SERVICE BULLETIN

NUMBER: 06-33-04
DATE: 01/15/04

SUBJECT: Disc Brake Pad Modification

FIG. 1 - Front Brake Pad

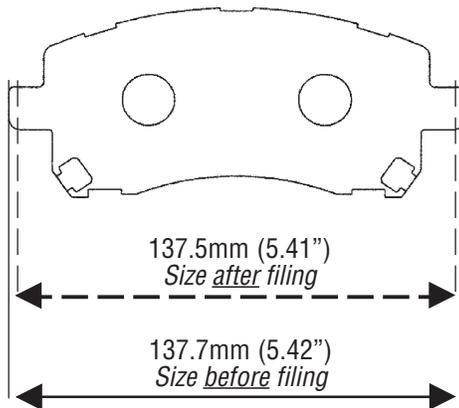
The purpose of this bulletin is to address unevenly or prematurely worn brake pads. There is the possibility that the pads are too tight in the caliper and have insufficient clearance as a result of rust buildup and dirt. If that is the case, the backplate of the disc brake pads will need to be slightly filed no more than 0.1mm (0.0039") on each end to remove the rust.

Be extremely careful when filing the backplate of the inner and outer brake pad. Make sure that both ends are filed evenly; do not file shorter than the dimensions shown below (Figure 1 & 2). Failure to do so will create a rattle or clank noise. After filing, make sure to apply grease on both ends of the backplate where filed.
